Dave Schettler, PE
Schettler Civil Engineering Services LLC
(for Construction Special Inspections)
57 Wedge View Ln
Leavenworth, WA 98826
Phone: (509) 669-5469

December 20, 2023

RE: **VCP Project No: CE0509, Lake Chelan Community Hospital, Facility/Site ID: 66314**
Response Document to Ecology - Mary Monahan's letter dated Dec. 13, 2023
on requested list of more information to be provided for review of VCP Opinion
for a No Further Action Determination

FIGURE A

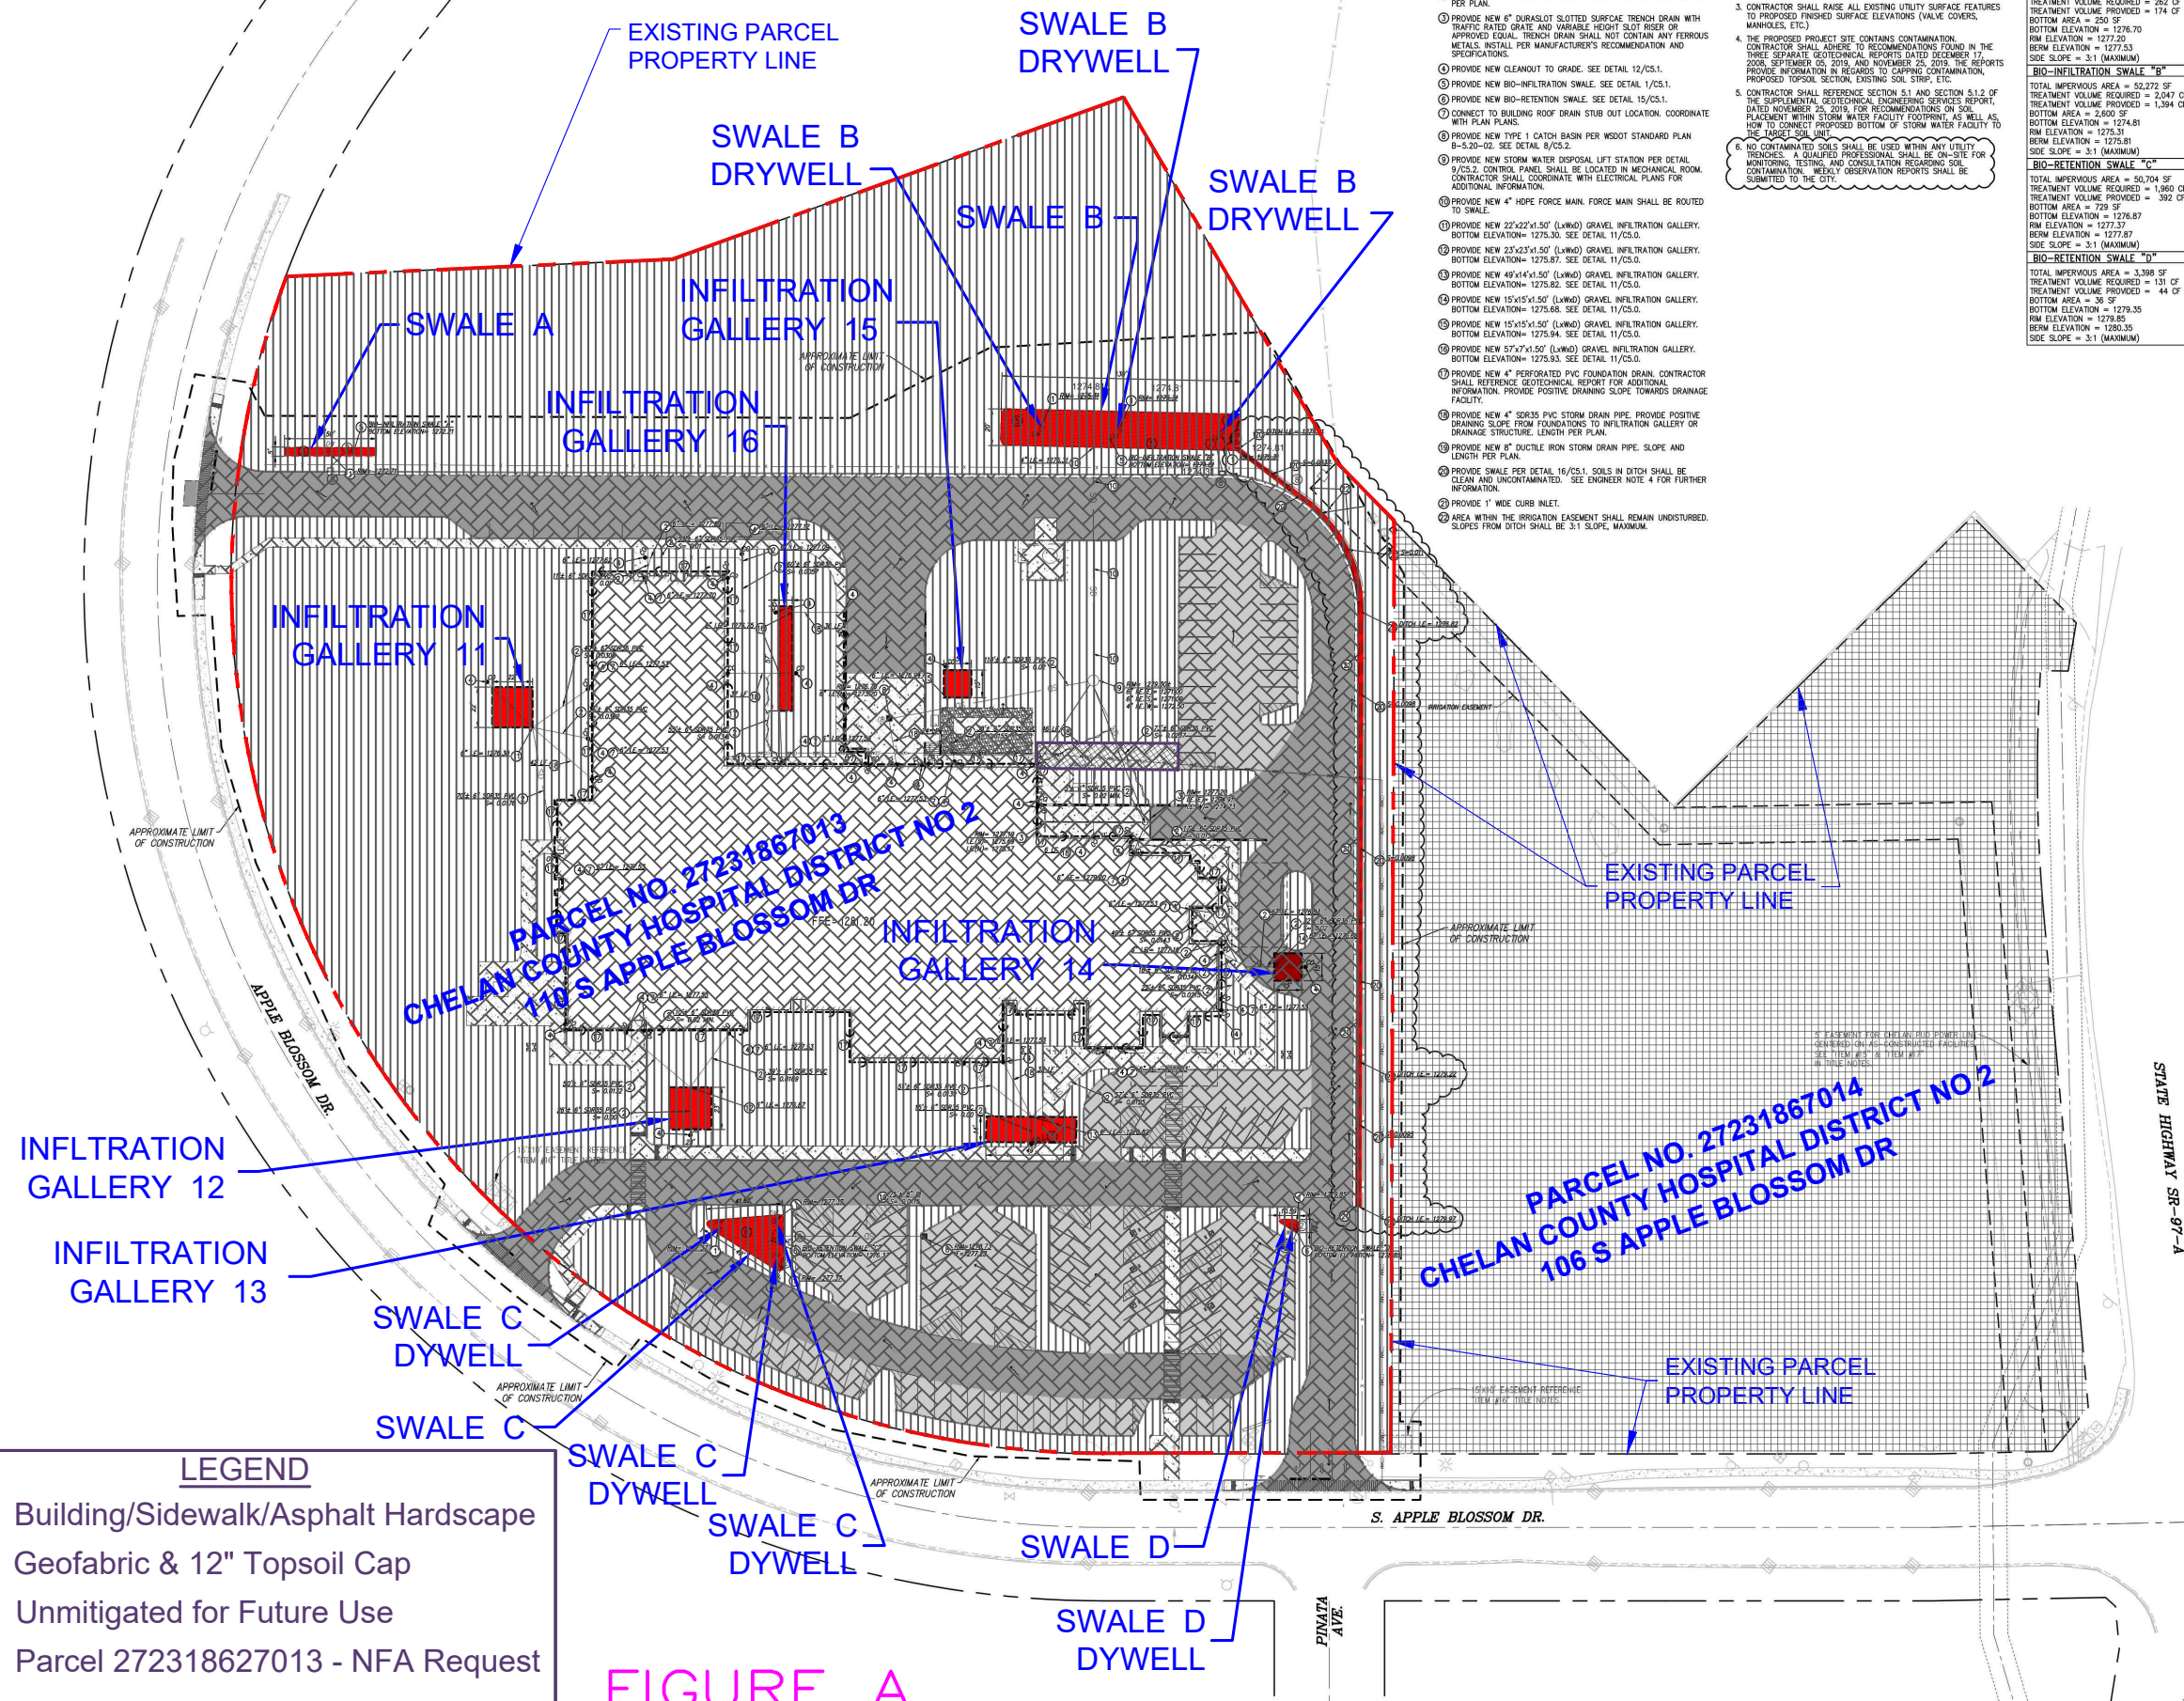
1. A figure that clearly details where areas of either or both parcels have been remediated. The figure should include the following elements-stormwater features and locations, clear delineation of where capping was completed, identification of type of hard cap or use of soft capping for landscaping, parcel boundaries and approximate volumes and concentrations of contamination left beneath any capping.

*Response: **Figure A - C1.3 Storm Water Plan** is attached and has been modified to show both parcel property line boundaries and identifies the south parcel, 110 S. Apple Blossum Road, parcel no 27231867013, as having been remediated with all surfaces of the parcel either covered with soft capping of 12-inches of clean soil with underlying geotextile material or hardscaped with pavement for roadways and parking, concrete sidewalks, or newly constructed building for the hospital. **Figure C1.3** clearly details where capping has been completed and identifies the types of hard cap as either building structure, asphalt pavement, concrete sidewalks, and soft capping of geotextile with 12-inches of imported clean soil capping. **Figure C1.3** also calls out the approximate volumes and concentrations of contamination left beneath the capping for the total area of the remediated parcel (parcel no. 27231867013).*

Approximate Volume of Contaminated Soils with levels above MTCA beneath capping materials on Parcel No. 27231867013 = 602,257 cubic yards. Approximate levels of lead and arsenic left beneath the capping materials is estimated to be as follows: Arsenic ≈ 77 mg/kg, Lead ≈ 292 mg/kg.

FIGURE B — OVERALL SITE PLAN

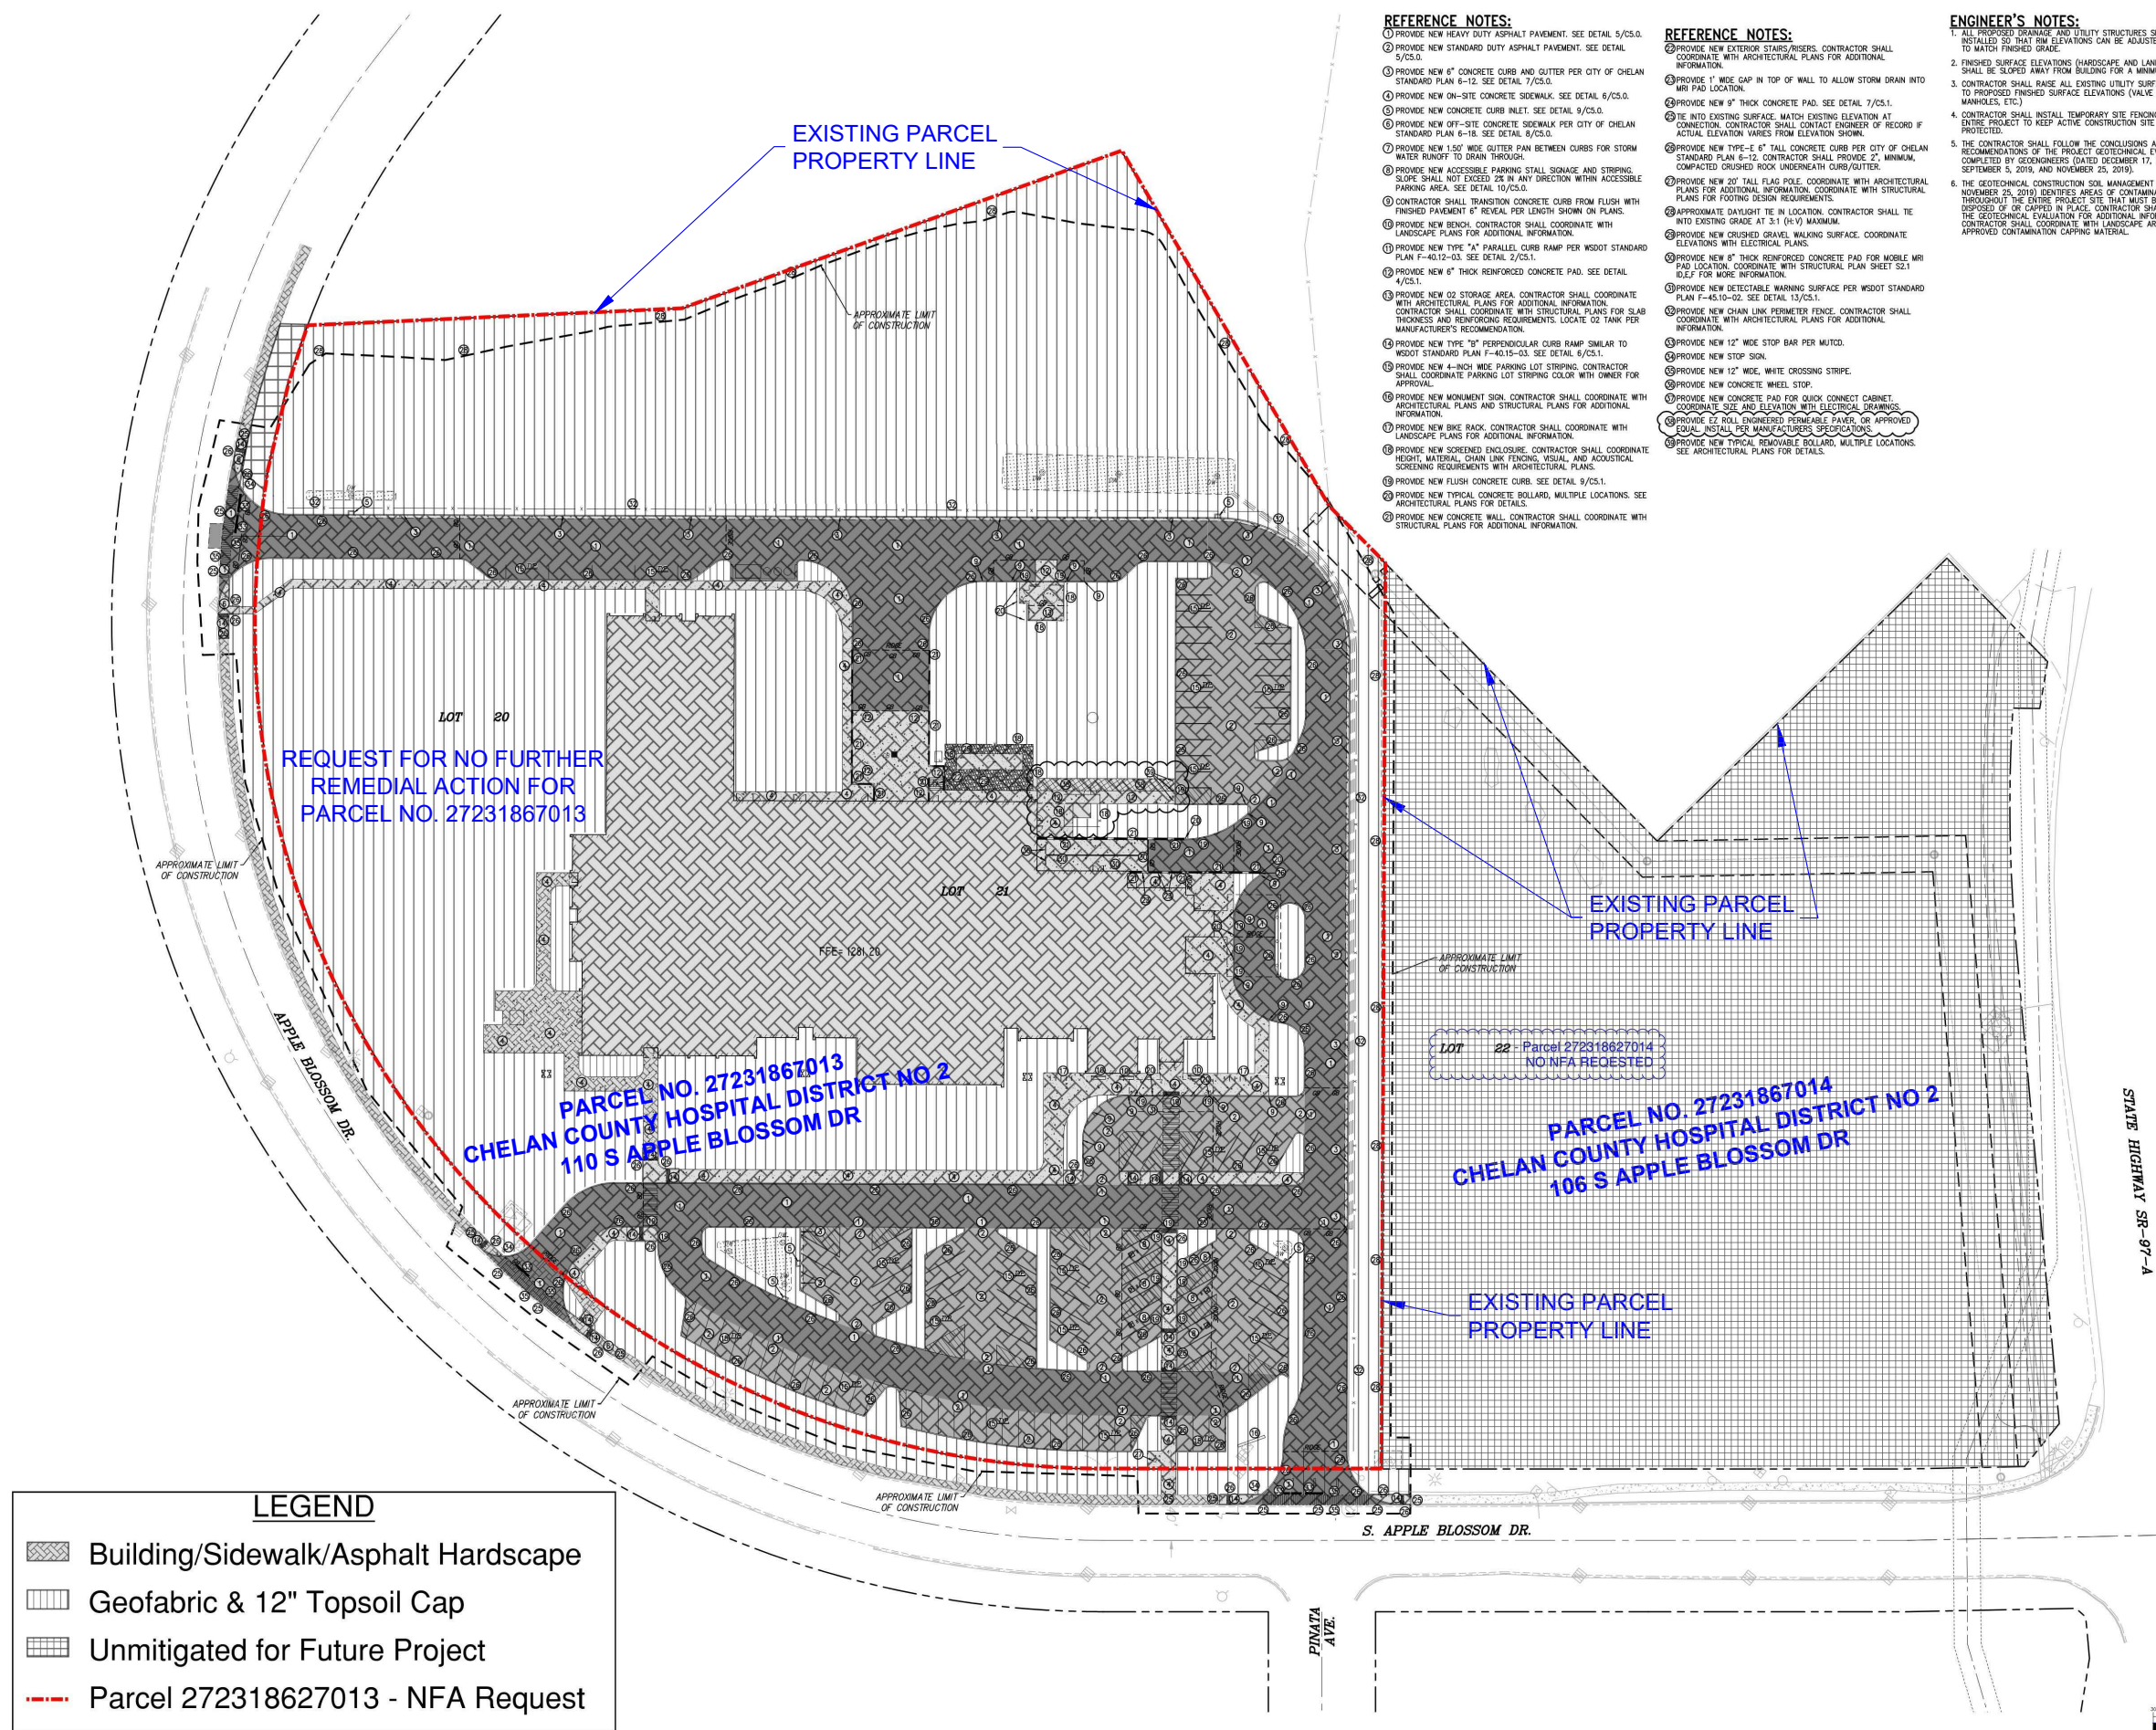
2. If soils have been imported to complete any soft capping, sampling should have been conducted on the imported soils to assure that concentrations of contamination do not exceed MTCA cleanup levels.

Please provide any documentation you may have regarding these items. In lieu of sampling data, you may provide final sampling data for all soft capped areas that show concentrations of contamination that are below 20 mg/Kg for arsenic and 250 mg/Kg for lead.

*Additional soil sampling of the 12-inch thick soil capping performed on the remaining area that was capped this last summer for the area highlighted in green on the attached **Figure B – C1.3 Site Plan**. **Figure B** also shows the locations of the six (6) soil samples taken to confirm the imported soil is not contaminated with lead and arsenic. This final sampling data for that soft capped area shows concentrations of contamination are below 20 mg/Kg for arsenic and 250 mg/Kg for lead.*
